DATE: February 17, 2016

TO: Design Review Commission
FROM: Sierra Davis, Assistant Planner
SUBJECT: 15-SC-45 – Los Pajaros Court

15-SC-45 – 419 Los Pajaros Court

Location of trees and their Tree Protection Zones

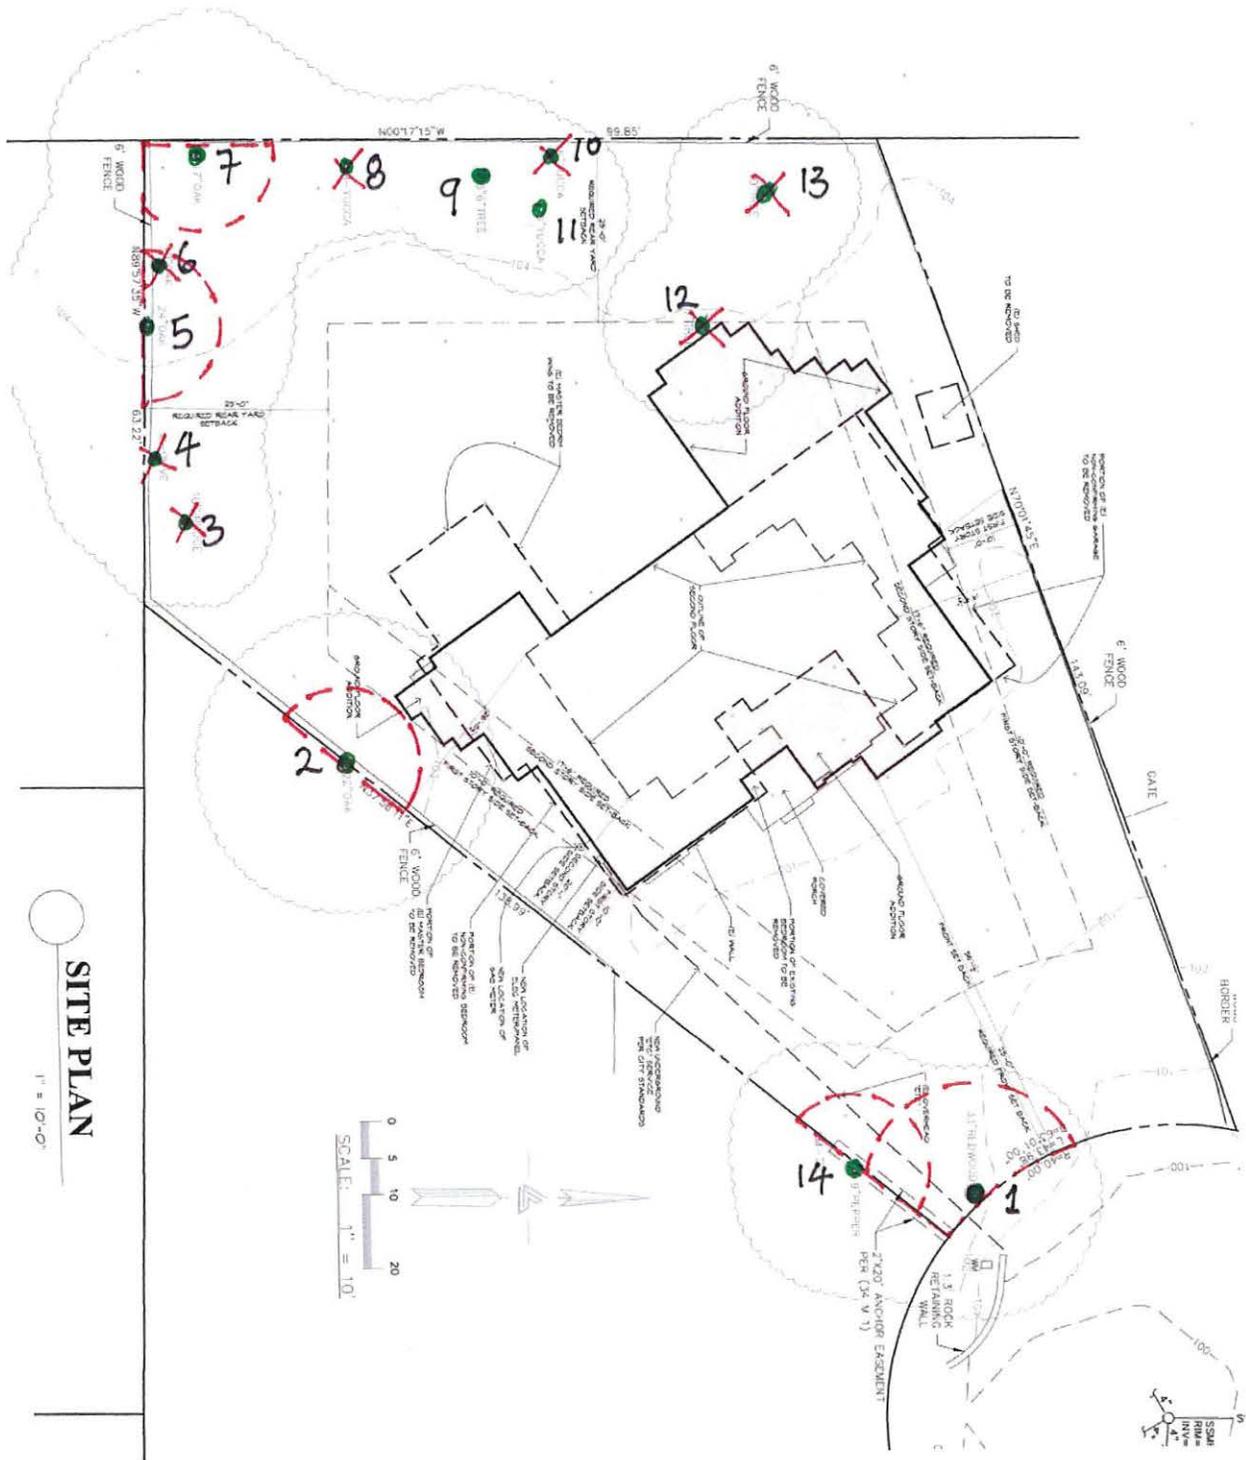
Tree #s 3, 4, 6, 8, 10, 12 and 13 are either in poor health and condition or are poor species and so I have recommended removal.

Tree #s 1, 2, 5, 7 and 14 are all good healthy trees that should be retained and protected during construction.

Tree # 1: the TPZ should be at a radius of 15 feet from the trunk closing on the sidewalk and fence line of the tree in accordance with Type I Tree Protection as outlined and illustrated in image 2.15-1 and 2 ⁽⁶⁾

Tree #s 2, 5, 7 and 14: the TPZ should be at a radius of 10 feet from the trunk of the tree closing on the fence line in accordance with Type I Tree Protection as outlined and illustrated in image 2.15-1 and 2 ⁽⁶⁾

Tree protection fencing shall be installed around the dripline, or as required by the project arborist, of the following trees (No(s). 1, 2, 7, 5, 14) as shown on the site plan. Tree protection fencing shall be chain link and a minimum of five feet in height with posts driven into the ground and shall not be removed until all building construction has been completed unless approved by the Planning Division.
